**MEMORANDUM**

**TO:** CHAIRMAN AND MEMBERS OF THE PLANNING COMMISSION  
**FROM:** DIRECTOR OF PLANNING, BUILDING AND CODE ENFORCEMENT  
**DATE:** JUNE 24, 2008  
**SUBJECT:** VESTING TENTATIVE TRACT MAP NO. 68796, ET AL. (CASE NOS. SUB2007-00003 & ZON2007-00072); PROPOSED 27-UNIT CONDOMINIUM PROJECT AT 28220 HIGHRIDGE ROAD

**TO: KIT FOX, ASSOCIATE PLANNER**  
**FROM: JOANNE ITAGAKI, CONSULTANT TRAFFIC ENGINEER**  
**DATE: June 11, 2008**  
**SUBJECT: DRAFT TRAFFIC IMPACT ANALYSIS FOR 28220 HIGHRIDGE ROAD RESIDENTIAL DEVELOPMENT – May 6, 2008**

Figure 1 illustrates the project site location and study area intersections.

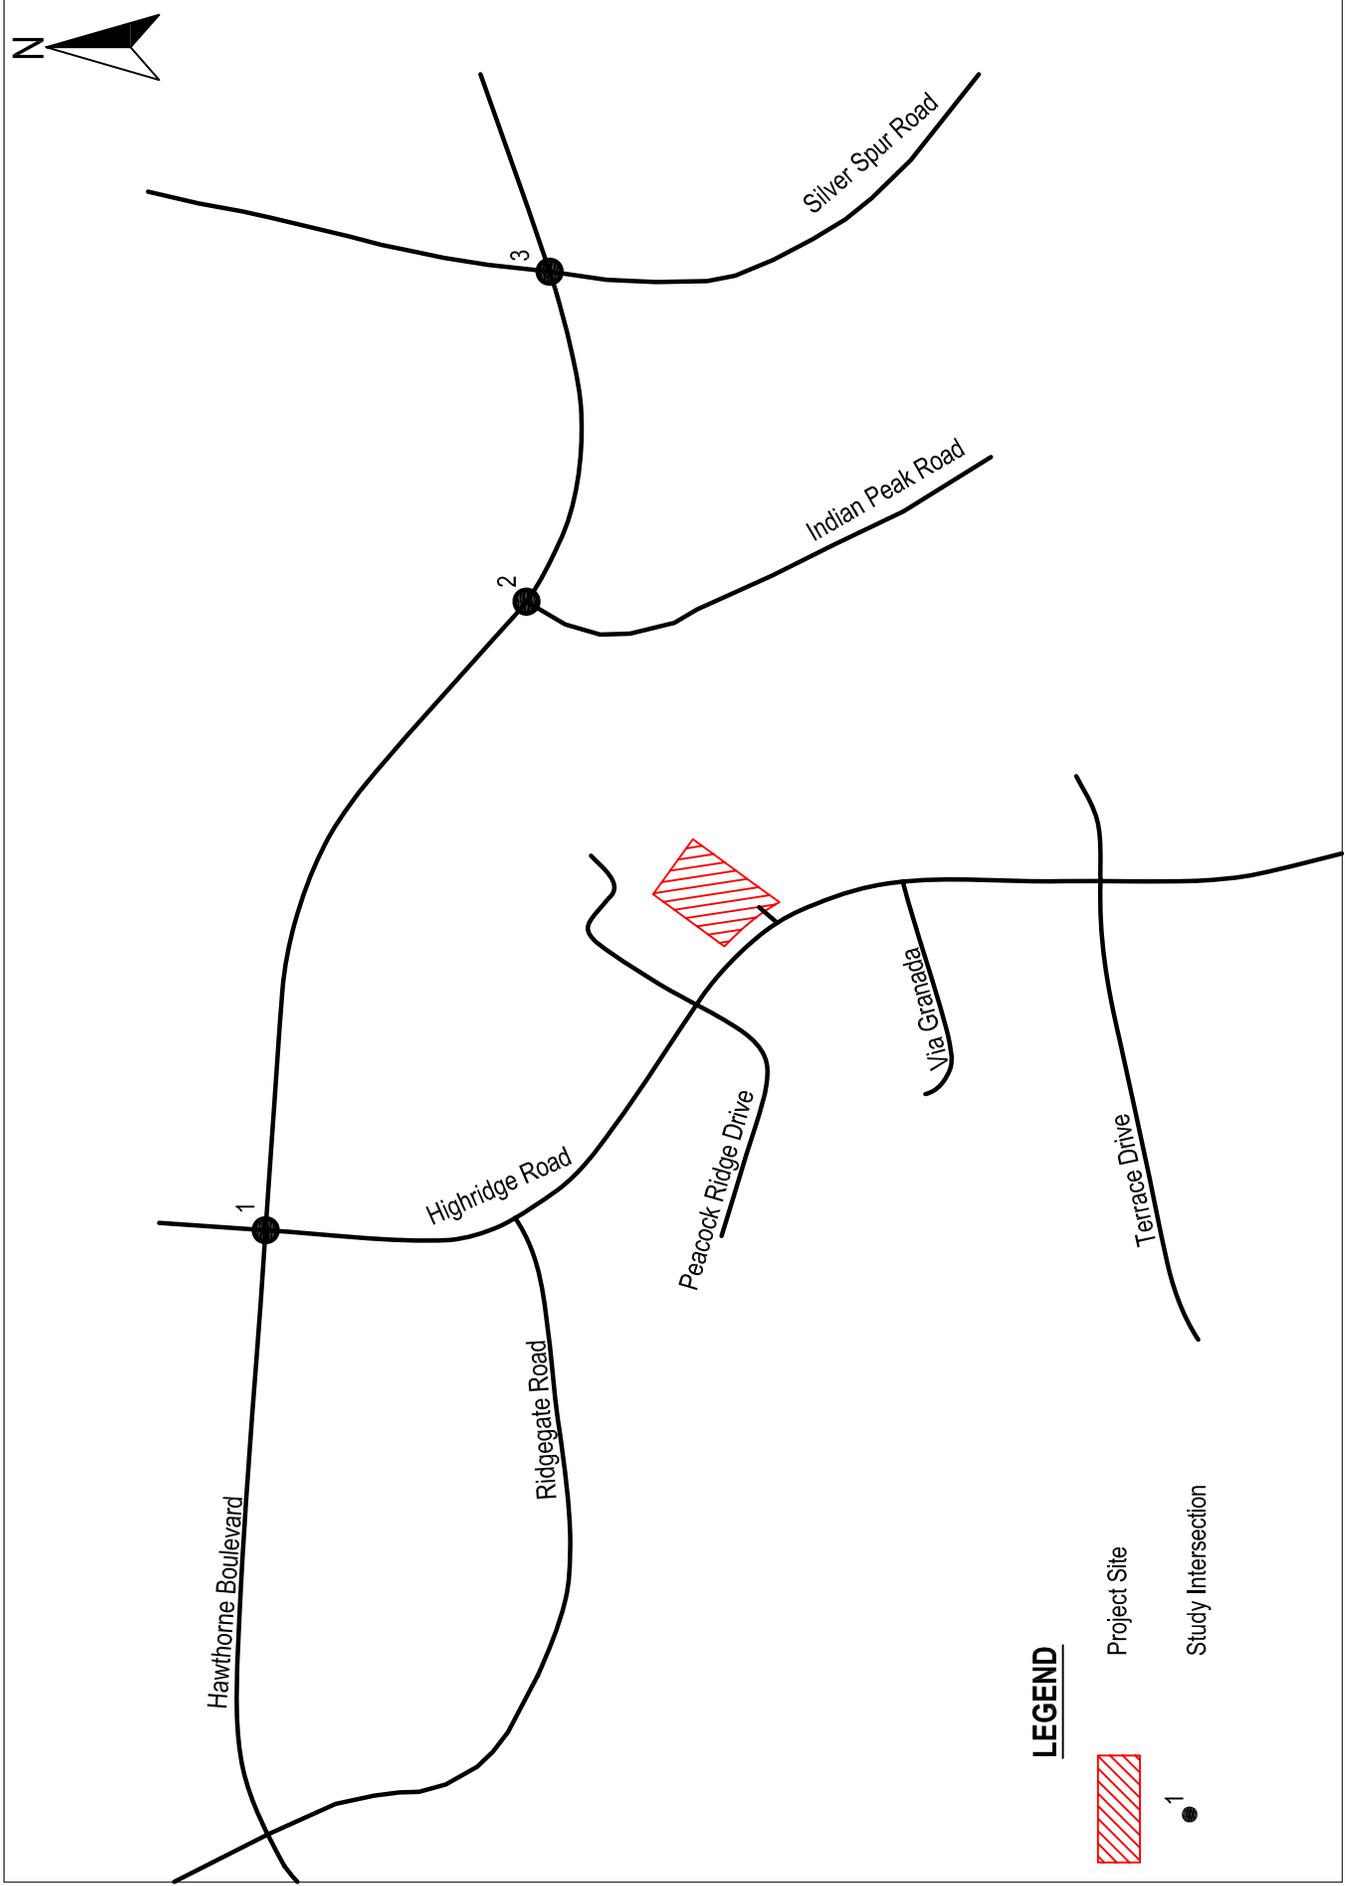
1. Page 3, "Site Location and Study Area", 2<sup>nd</sup> sentence – This sentence indicates the project is located "between **Peacock Road** and Via Granada." This should be **Peacock Ridge Road** as shown on Figure 1.
